Landmarks Preservation Commission Planning and Development Services Department

Date: May 25, 2022
Time: 5:30 p.m.
Location: Virtual (see below)

STAFF REPORT

AGENDA ITEM 4A: 911 N. J Street

DRAWN
AJH
CHECKED
ABG
DATE
05/12/22
SCALE
AS NOTED
JOB NO.
001
SHEET
A-3.0
BUILDING ELEVATIONS

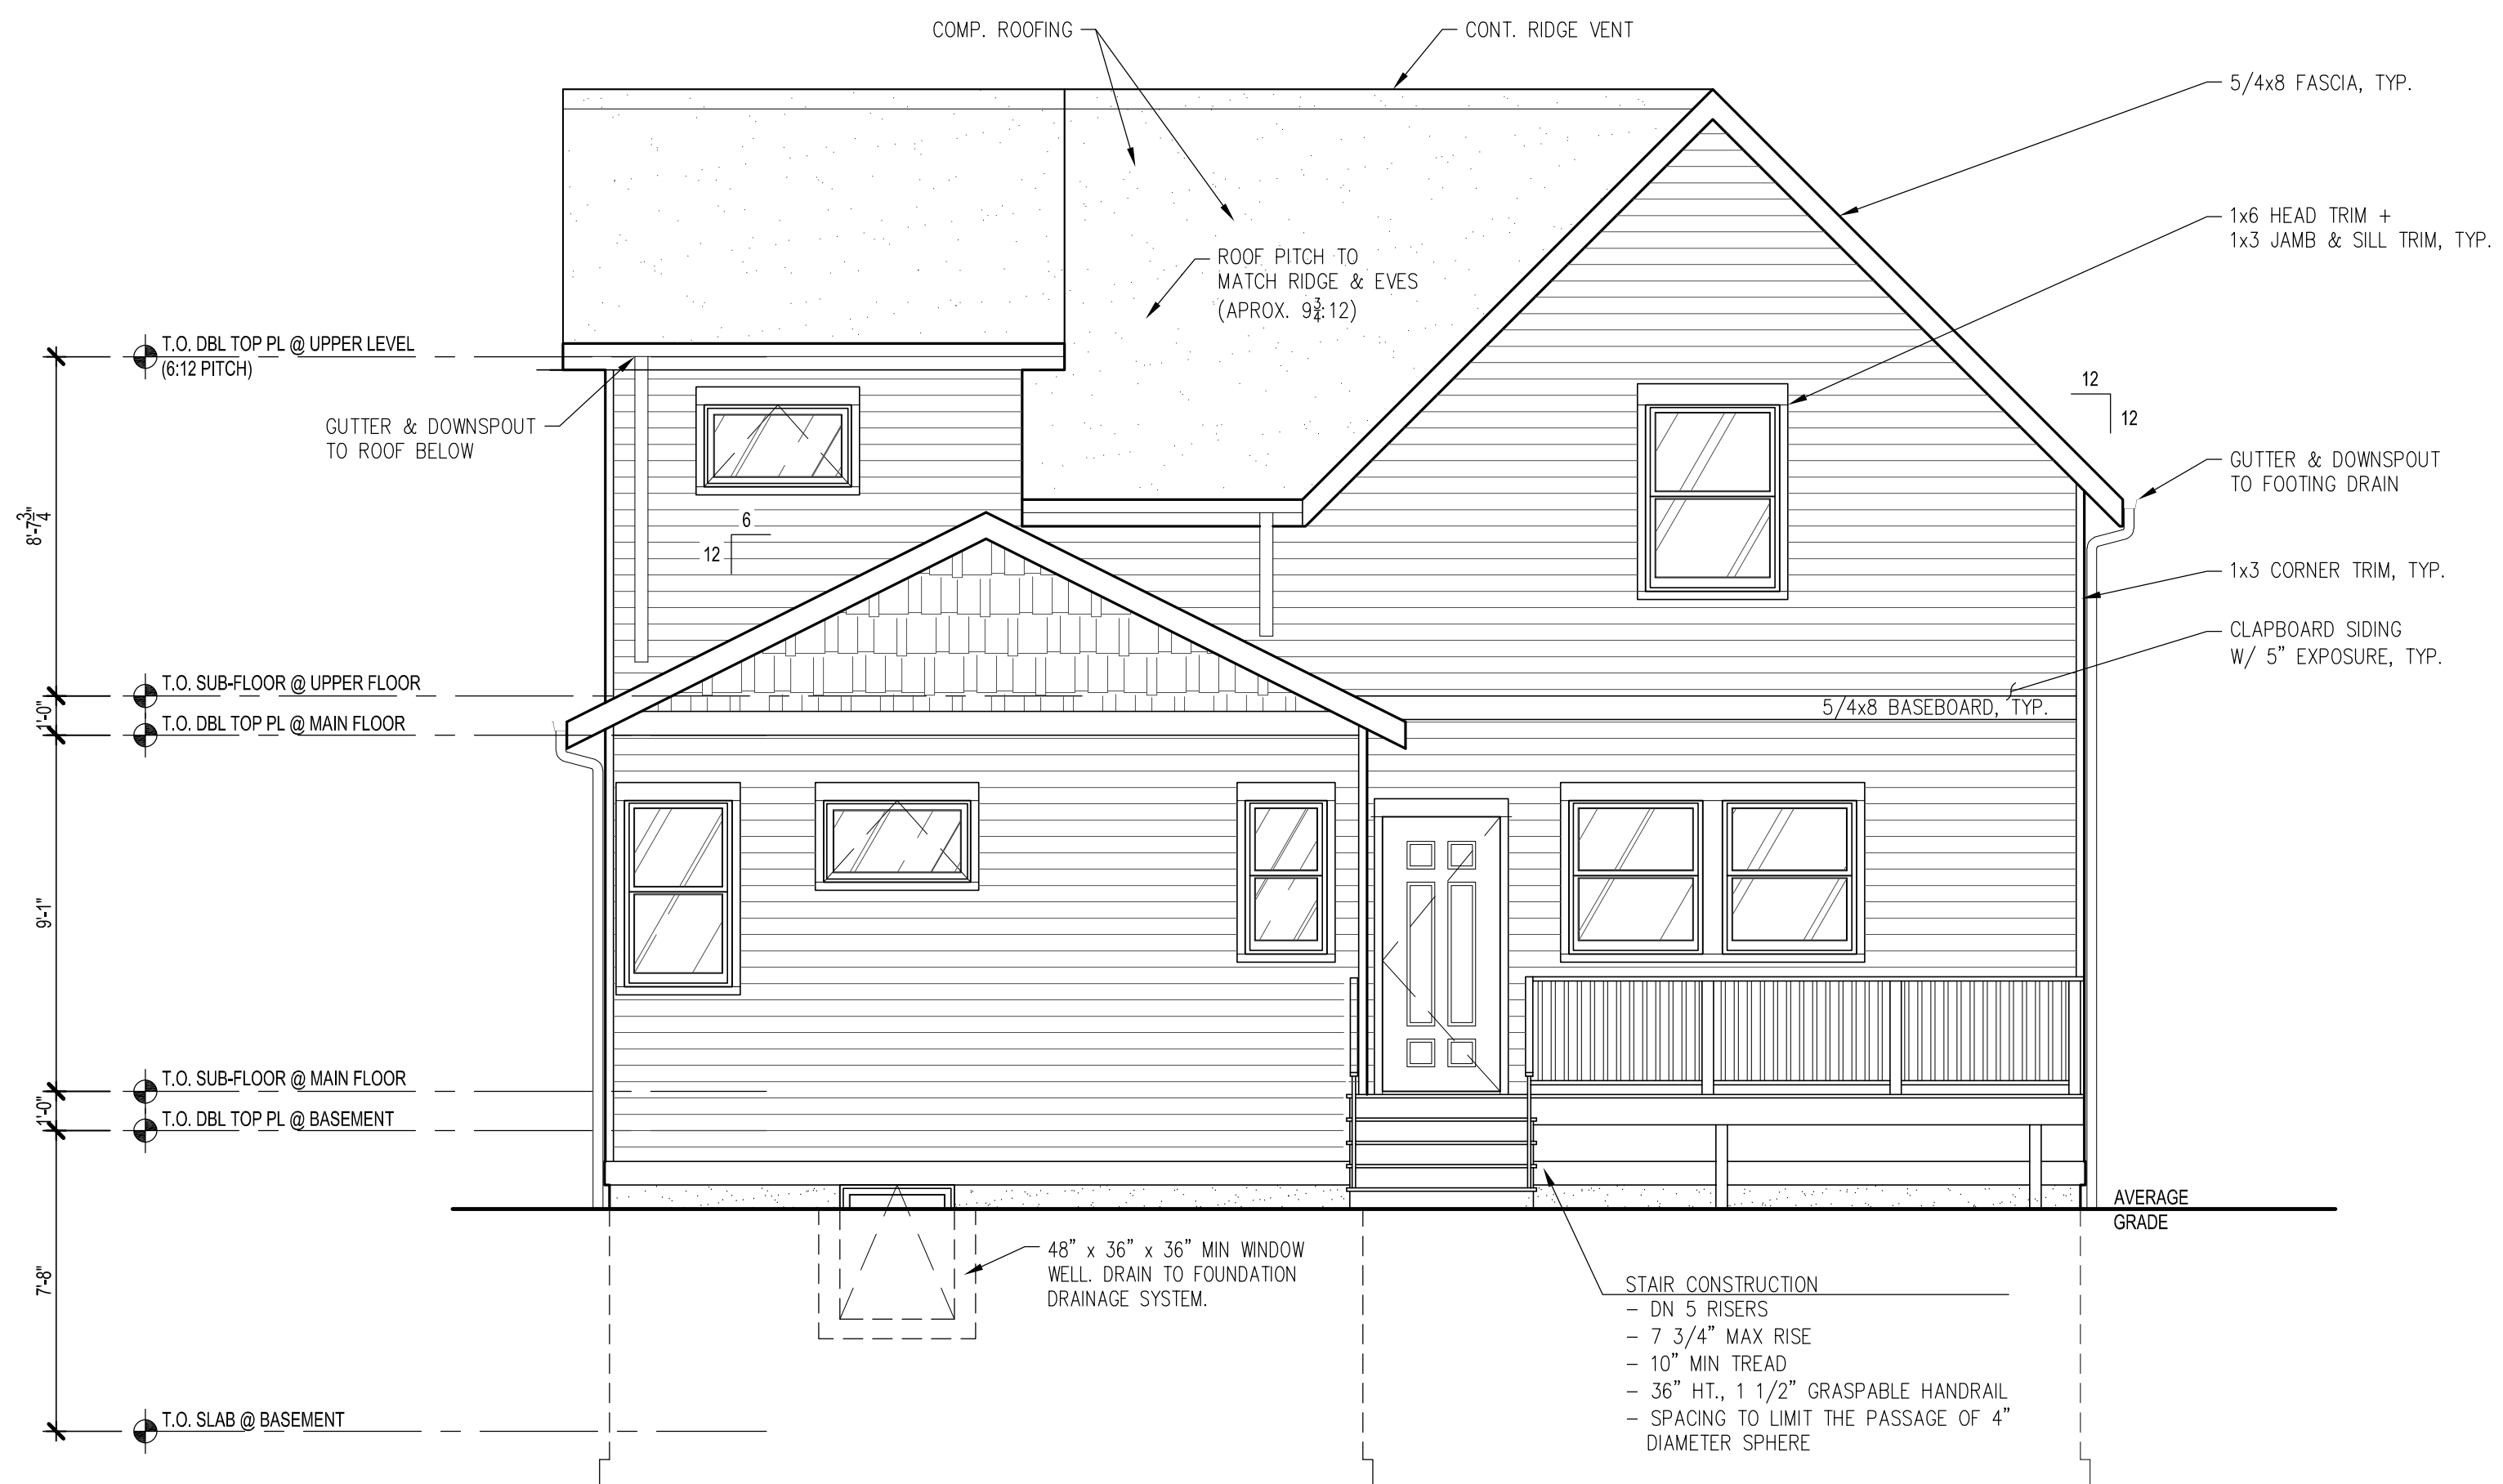
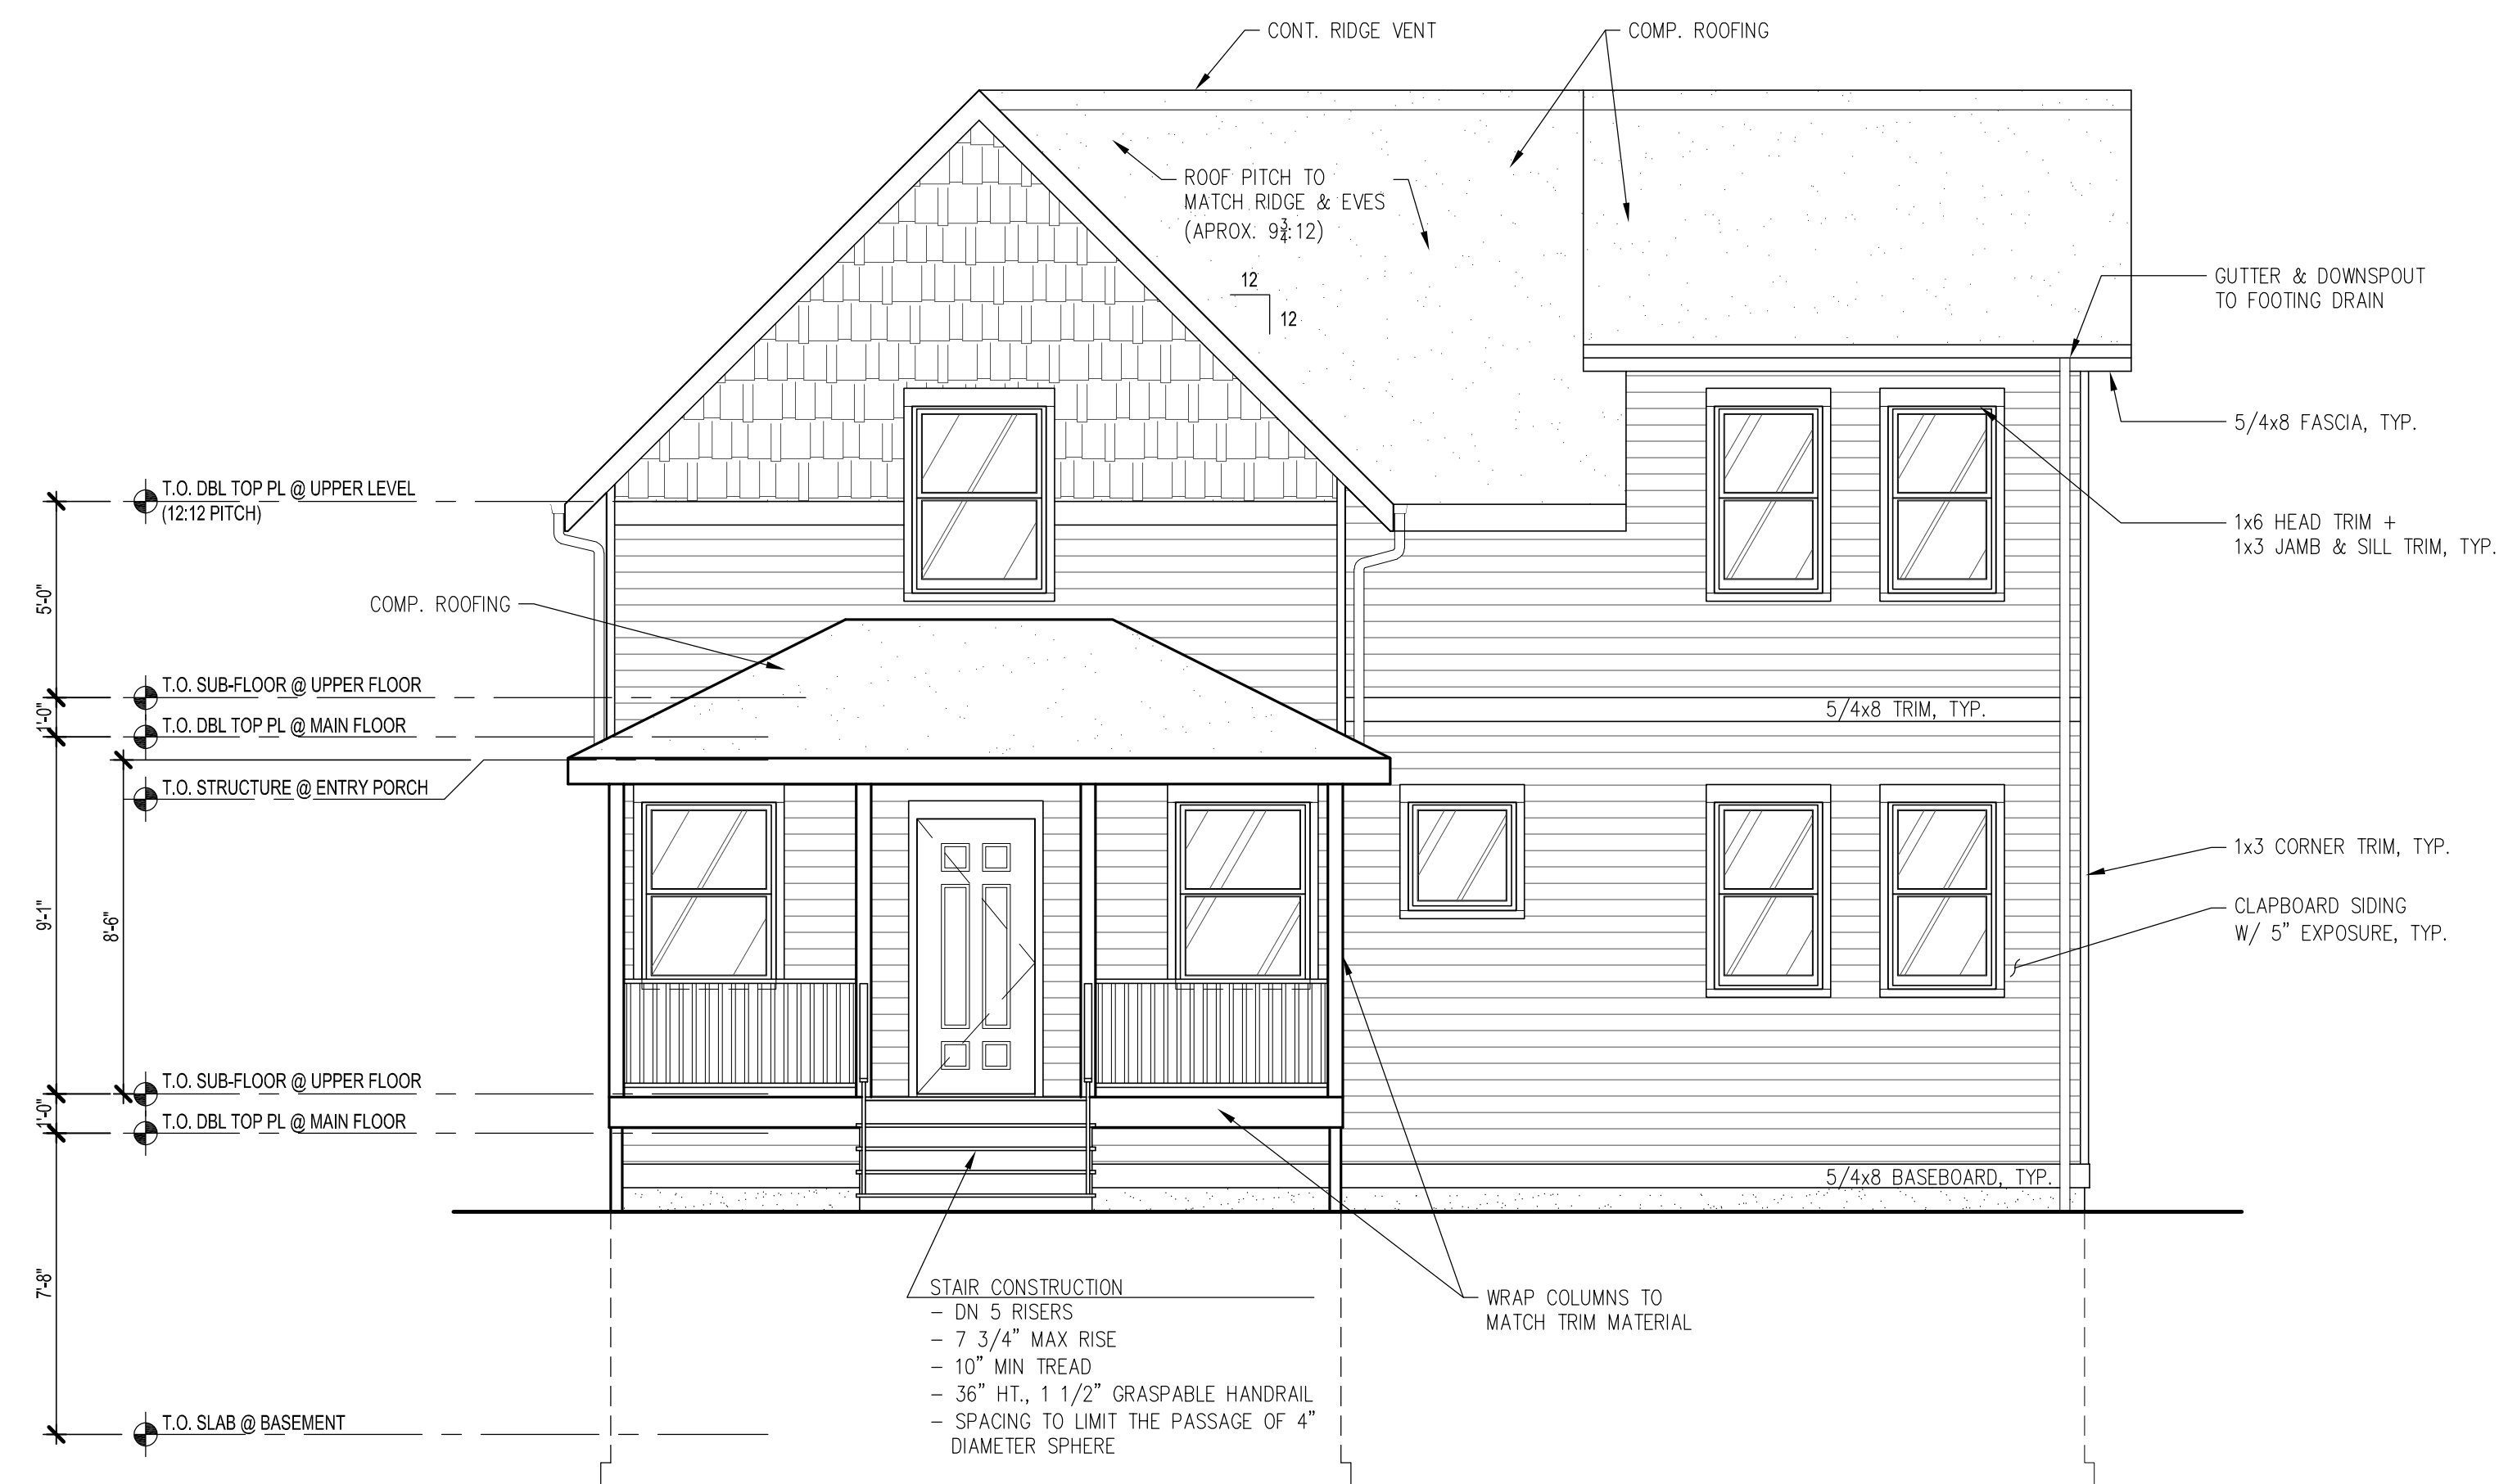
6. The Wedge and North Slope Historic District Design Guidelines apply to this proposal.
7. The proposed structure is slightly over 28' in height. The original structure was 27'10" according to plans approved in 2016. The guidelines for height state, "New buildings should be comparable in height to adjacent structures." Although a height survey has not been requested or conducted, adjacent structures do not appear to be as tall as the proposed height or the original home, in part due to their different architectural eras (the home to the east is a

- craftsman bungalow, and the home to the west is an English Cottage). However, the proposed house appears to meet the height guideline.
8. The guideline for scale states, “building facades should be of a scale compatible with surrounding buildings and maintain a comparable setback from the property line to adjacent buildings, as permitted by applicable zoning regulations.” The proposed design appears to maintain the residential architectural scale and is set back consistent with current development standards. The footprint of the home on the lot was shifted east of the location of the original house due to current setback requirements.

9. The guideline for massing states in part, “Variety of forms is a distinguishing characteristic of the North Slope and Wedge residential communities. Smaller massing—the arrangement of facade details, such as projections and recesses—and porches all help to articulate the exterior of the structure and help the structure fit into the neighborhood. Avoid large, blank planar surfaces.” The proposed design includes massing typical of detached dwellings in the historic district and appears to meet this guideline.

10. The guideline for “sense of entry” states, “: Entrances should be located on the front facade of the building and highlighted with architectural details, such as raised platforms, porches, or porticos to draw attention to the entry. Entrances not located on the front facade should be easily recognizable from the street.” The proposed design includes a clearly defined porch located on the front elevation, thus appearing to meet this guideline.

11. The guideline for “roof shapes and materials” notes that roof pitches for new structures should be between 5:12 and 12:12, and should utilize elements such as dormers and cross gables to break up large blank surfaces. The proposed design includes a primary 12:12 pitch with a cross gable/shed dormer at 6:12, thus meeting this guideline.

12. The guidelines for windows state that windows should share header heights with other doors and windows, utilize configurations similar to those typically found in the district, and should be wood or have an appearance like wood (such as a clad material). The proposed windows are primarily double hung, with hopper/awning casement windows. The windows are proposed to be clad wood and appear to meet this guideline.
